WEST SUSSEX COUNTY COUNCIL CONSULTATION

TO:	Horsham District Council FAO: Amanda Wilkes
FROM:	WSCC – Highway Authority
DATE:	10 July 2025
LOCATION:	Stonehouse Farm Handcross Road Horsham RH13 6NZ
SUBJECT:	<p>DC/25/0403</p> <p>Full Planning Application to form a comprehensive masterplan including:</p> <ol style="list-style-type: none"> 1. Rationalisation and enhancement of existing commercial facilities (Use Classes E(g) B2 and B8 at Stonehouse Business Park including demolition of two buildings and their replacement with new Class E(g), B2 and B8 facilities. Extension of existing building to form a new office and wardens' accommodation. Existing mobile home removed. 2. Decommissioning of the Anaerobic Digester and re-use of the existing 2no buildings for storage and office uses (Class E (g) and B8) and the diversion of a public footpath. 3. Residential redevelopment of the Jacksons Farm site including the demolition of existing barns to provide 3no. dwellings with access, parking, and landscaping. <p>More information received from Dominic Smith's email on 1st July 2025.</p>

This is the second WSCC Highways response to the above planning application seeking full Planning Applicati

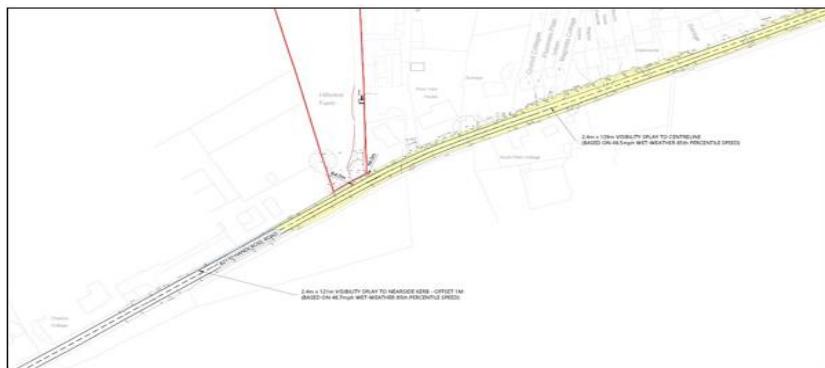
2. With regard to the visibility splays offered, these are less than those recommended in DMRB for a road with a 50mph speed limit. Applicant to provide further explanation and justification about this, please, particularly given that trips to and from the site are shown to increase if this proposal is approved.

Having reviewed this, the text above conflicts with what's shown on the plan. Although the plan shows a visibility splay of 2.4m x 121m in the leading traffic direction (looking west from the access) taken to a point 1.0m offset from the kerb line which is acceptable to the Highway Authority, the visibility splay of 2.4m x 129m in the trailing traffic direction (looking east from the access), is shown to the *centreline* of the road, which is generally not acceptable to the Highway Authority as it does not meet DMRB requirements. If the splay is taken to the centreline, the full extent of the play is not available meaning that vehicles travelling west-bounds that might be overtaking other vehicles travelling in the same direction, could be 'lost' in the area on the nearside of the carriageway and, therefore, not visible to vehicles emerging from the access, which could result in conflicts. And although there is a fixed white line on this part of Handcross Road that instructs drivers not to overtake, extending approximately 45m in the leading traffic direction and 125m in the trailing traffic direction from the proposed point of access, there is no physical measure in the carriageway to stop indiscriminate overtaking. Therefore, the applicant should re-visit this and provide visibility splays to an offset of 1.0m from the nearside kerb line in both directions.

Handcross Road is subject to a 50mph speed limit – however, ATC data has been obtained that identifies mean and 85th percentile speeds. The data is provided at Appendix E and the speeds and resultant visibility splays using DMRB parameters are summarised in Table 3.1 (below):

Visibility splays at the access have been reviewed in this context. The updated access drawing ITS19302-GA-009 demonstrates the splay to a 1m offset from the nearside kerb line. The splays are achievable within land under control of the Applicant / within the highway boundary, with some maintenance of vegetation that has overgrown into the highway. This maintenance will be undertaken as part of the works required to implement the access improvements under license from WSCC. An extract of the drawing is provided in Image 3.1 (below):
